Access Compliance Report

Public Rights-of-Way

Intersection ID: 32074	Main Street: SPRINGBANK_LN	Cross Street: SPRINGS_VILLAGE_LN	Location: NE
ADA ID: B3BFA071C70F	Ramp Type: PerpDiag	Initial Pass/Fail: Fail	Overall Compliance: No
Severity Score: 13.75			
Codes/Mitigation Info/Possible Solution		Field Measurements/Component Compliance

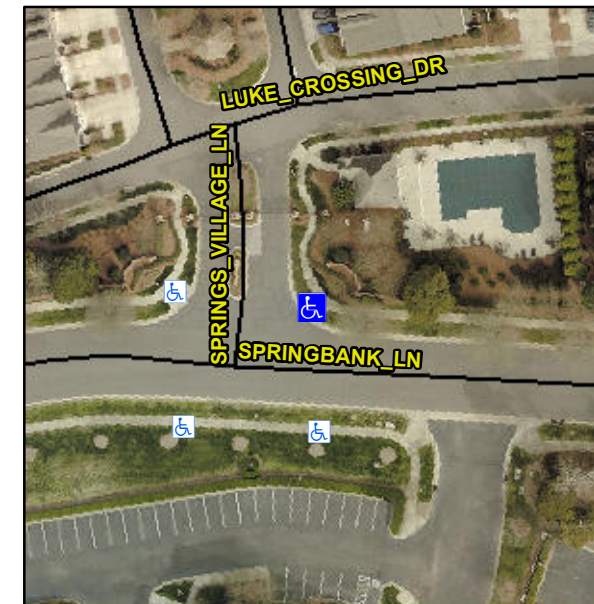
Not Found, R304.2.2, R304.5.3

Compliance	Description	Data	Compliance	Description	Data
N/A	Ramp Length (in)	96.0	No	Ramp Slope (%)	11.1
Yes	Ramp Width (in)	51.0	No	Ramp XSlope (%)	2.7
N/A	Flare Type LT	N/A	N/A	Flare Type RT	N/A
N/A	Flare Slope LT (%)	N/A	N/A	Flare Slope RT (%)	N/A
N/A	Flare Traversable LT?	N/A	N/A	Flare Traversable RT?	N/A
N/A	Landing Length (in)	N/A	N/A	DWS Provided?	N/A
N/A	Landing Width (in)	N/A	N/A	DWS Contrast?	N/A
N/A	Landing Slope (%)	N/A	N/A	DWS Length (in)	N/A
N/A	Landing X Slope (%)	N/A	N/A	DWS Full Width?	N/A
N/A	Landing Curb? (Y/N)	N/A	N/A	DWS Offset (in)	N/A
N/A	Shared Landing?	N/A			
N/A	Gutter Ponding?	N/A	N/A	Gutter Slope (%)	N/A
N/A	Gutter Lip Ht (in)	N/A	N/A	Gutter X Slope (%)	N/A
N/A	Painted X Walk1?	No	N/A	Painted X Walk2?	No
	X Walk 1 Direction	To NW		X Walk 2 Direction	To S
N/A	X Walk 1 Width (in)	N/A	N/A	X Walk 2 Width (in)	N/A
	X Walk 1 Slope (%)	1.0		X Walk 2 Slope (%)	7.2
	X Walk 1 X Slope (%)	5.5		X Walk 2 X Slope (%)	3.4

Remove & Replace Curb Ramp With Two New Directional Ramps or Equivalent.
